Response to anonymous Referee #2

Interactive comment on “Building Asset Value Mapping in Support of Flood Risk Assessment: A Case Study of Shanghai, China” by Jidong Wu et al.

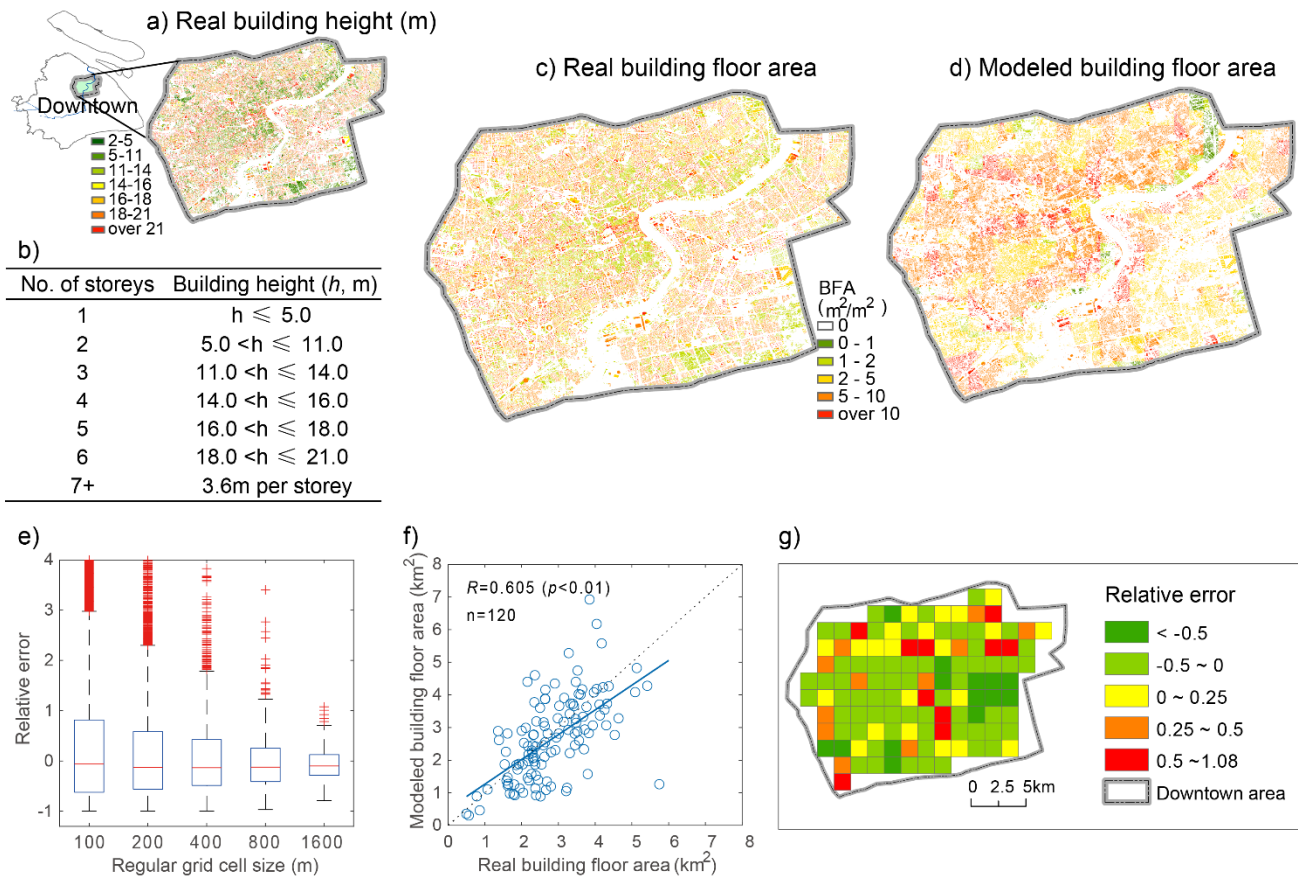
7) Evaluation of the proposed method. Fig.5 shows a comparison between modeled and real statistical building floor area (BFA). Despite the fact that the comparison is carried out at the district level (i.e., at a very coarse resolution), substantial discrepancies are shown, particularly for small values of BFA. Why?

Response: Thank you for your comment. Firstly, as shown in Figure 5 and Table 2 in the manuscript, for most of the districts the total BFA is less than 50 km². For each district in each building category (i.e., low-, medium- or high-rise building), we compare the census statistical value and modeled value (shown in Figure 6). As explained in the manuscript, “*The figure also shows that most of the district’s medium-rise BFA is slightly overestimated, whereas both low-rise and high-rise BFA are slightly underestimated for most of the districts. The spatial resolution of the LandScan population density data is approximately 800m for Shanghai. This coarse resolution smooths out the high- and low- population density area compared to a 2.5m spatial resolution of the building footprint map that is used here. This may be the main reason for the overestimation of medium-rise BFA in most of the districts of Shanghai.*”

Moreover, the population density is not perfectly correlated with building floor area, such as villa’s in residential areas and ‘villages’ in the city/. The spatial heterogeneity for this correlation should be even larger at a finer spatial scale. Substantial discrepancies are higher when the spatial resolution is higher (as shown in Figure 6e below, which will be added in the revised manuscript).
